INFORMATION LETTER 206L-09-86

TO: All Owners/Operators of Bell 206L Series Helicopters

SUBJECT: SUSPECT FLAP RESTRAINT SUPPORT 206-010-191-001

Figure 1. Discrepant Flap Restraint Support 206-010-191-001.

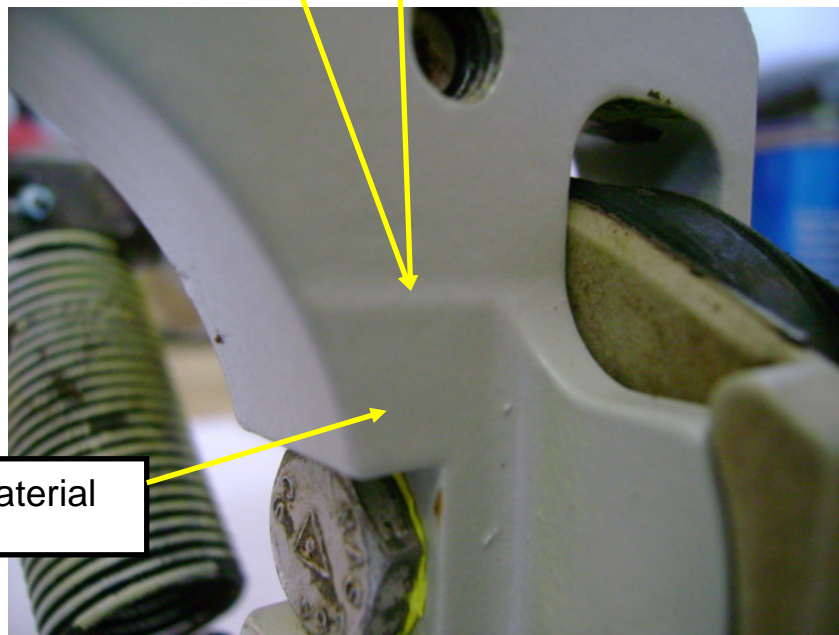
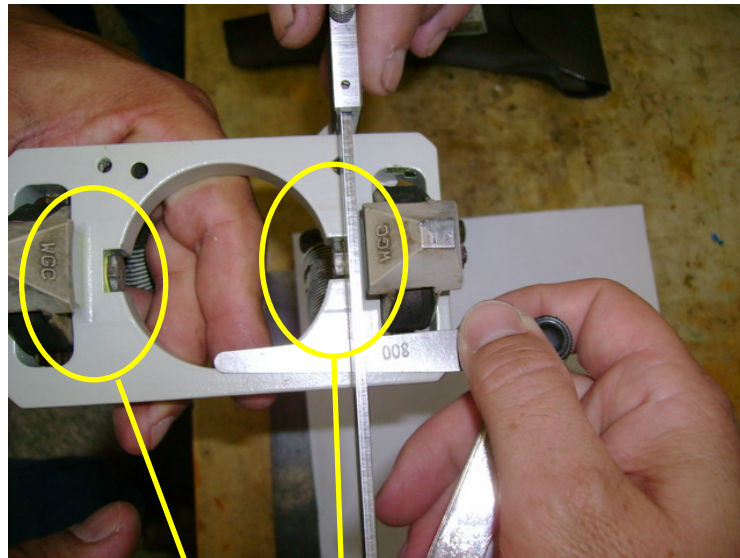
Bell Helicopter has received two reports of flap restraint supports 206-010-191-001 that were not manufactured to Bell Helicopter specifications. These supports have two raised areas on the lower surface that contacts the main rotor trunnion as shown on page two. This condition is not considered detrimental to the normal operation of the helicopter however if discrepant parts are found, contact Product Support Engineering for further instructions.

Raised material
